Attachment 4 – Summary of Changes to Draft Parramatta Development Control Plan.

This document outlines the changes recommended to be **supported** and able to be progressed with the Draft ‘Harmonisation’ Parramatta Development Control Plan (DCP) at this time (post exhibition prior to finalisation).

Table 1 Changes that are supported to be made to the DCP post exhibition prior to finalisation.

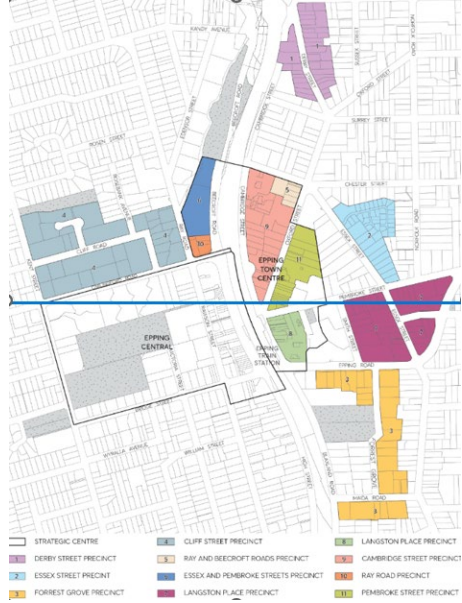
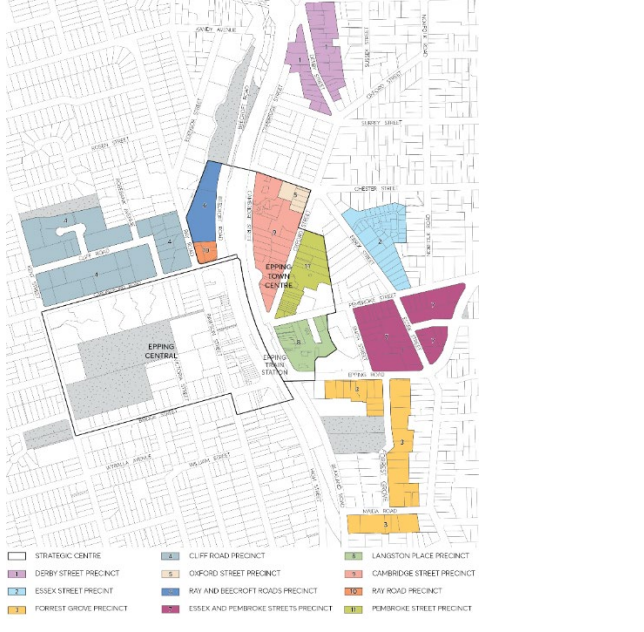
5.4.6 Natural Refrigerants in Air Conditioning	<p>The wording of the planning objective O.01 under Section 5.4.6 – Natural Refrigerants in Air Conditioning can be refined grammatically to avoid potential confusion to the DCP users.</p> <p>It is proposed to refine the wording to better communicate the intent of the objective.</p>	<p>Amend O.01 of Section 5.4.6 – Natural Refrigerants in Air Conditioning in red as follows:</p> <p><i>O.01 Reduce the greenhouse gas emissions associated with the release to the atmosphere through leakage or the improper disposal, of synthetic refrigerant gases with high Global Warming Potential (GWP).</i></p>	<p>Proposed amendments are considered minor and administrative to provide clarity on Council’s policy position regarding Natural Refrigerants in Air Conditioning.</p> <p>It is noted that Council received feedback from industry representatives regarding the safety of the refrigerants available to achieve a Global Warming Potential (GWP) of 10 or less as required under Section 5.4.6 – Natural Refrigerants in Air Conditioning. However, no change was made directly as a result of submissions received. As the proposed provisions within Section 5.4.6 – Natural Refrigerants in Air Conditioning currently apply to development within the Parramatta City Centre (via the Parramatta City Centre DCP 2011). The intention of draft Harmonisation DCP is to extend the control across the city more widely to reduce greenhouse gas emissions associated with leakage or the improper disposal of synthetic refrigerant gases with high Global Warming Potential (GWP); and to future proof new HVAC (air conditioning) systems. The proposed provisions are consistent with sustainability SEPP and relevant Council policy.</p> <p><i>See responses No.35.a and No.35.b in Table 2 of Attachment 3 - Submission Summary and Officer Response for more information</i></p>
